Recall Bulletin

F/CMVSS NONCOMPLIANCE RECALL

SUBJECT: Passenger Side Instrument Panel Performance

MODELS: 2009-2014 Chevrolet Express
2009-2014 GMC Savana
2500/3500 Series Equipped with Front Passenger Side Airbag (AK5) and
GVWR of 10,000 Pounds (4536 kg) and Below

3804499

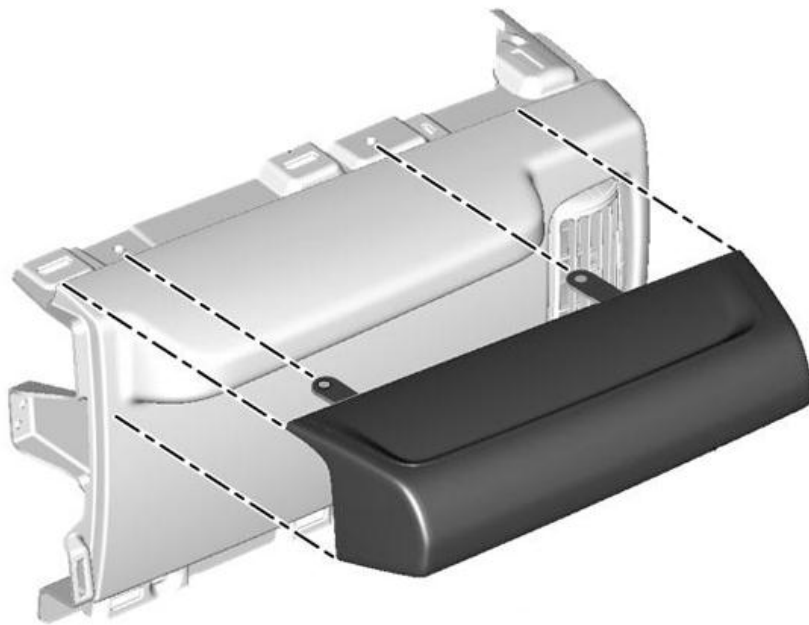
2. Remove the upper two screws that attach the instrument panel pad to the instrument panel bracket.
